1862 BARCLAY STREET (COMPLETE APPLICATION)
DE415926 - ZONE RM-5B

DEVELOPMENT PERMIT STAFF COMMITTEE MEMBERS

DEVELOPMENT PERMIT STAFF COMMITTEE RECOMMENDATION: APPROVE

Sheet Title: **PROPOSED WEST ELEVATION**

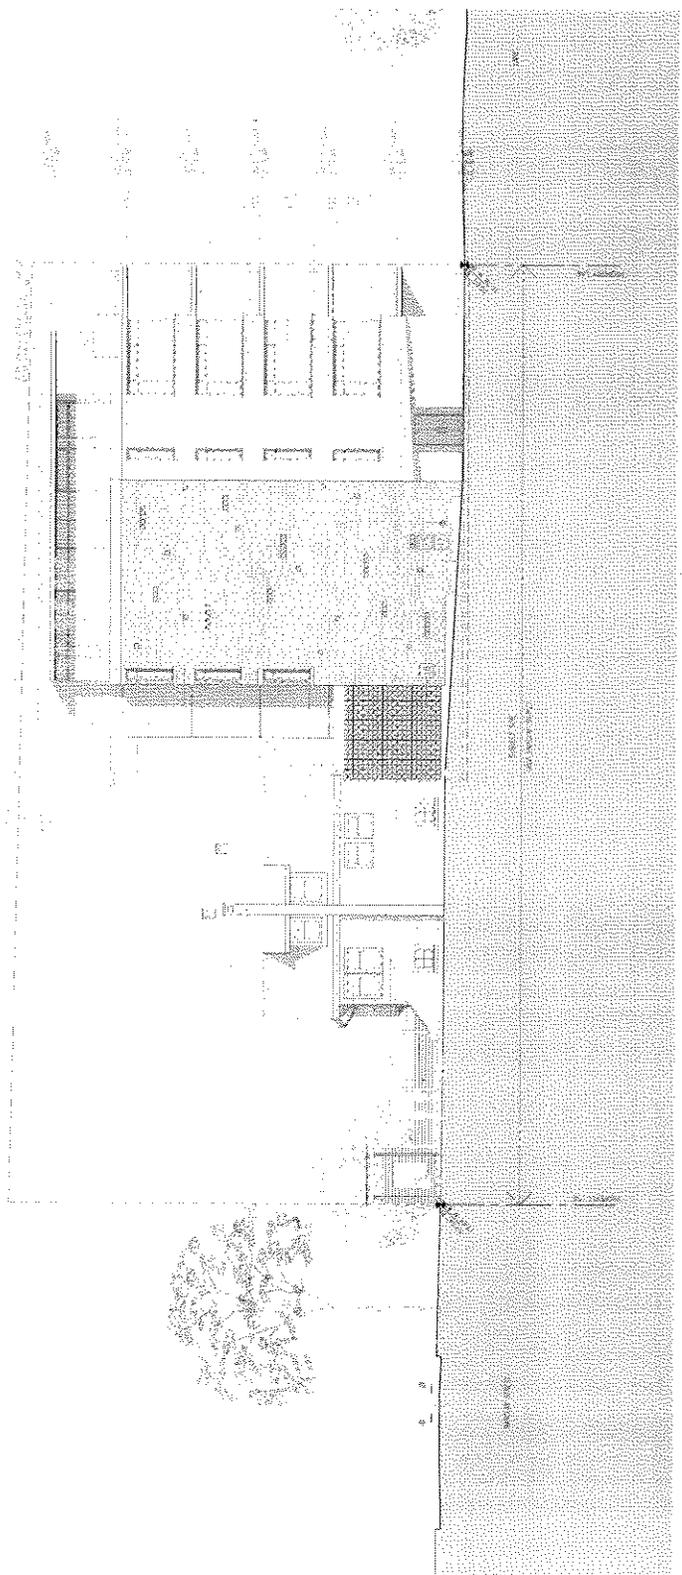
1.2 design development to reduce the privacy and view impacts of the six-storey addition to the nearest residential units on adjacent sites.

Note to Applicant: This can be addressed by the provision of translucent glazing, especially at those windows on the west side which are closest to the neighbors.
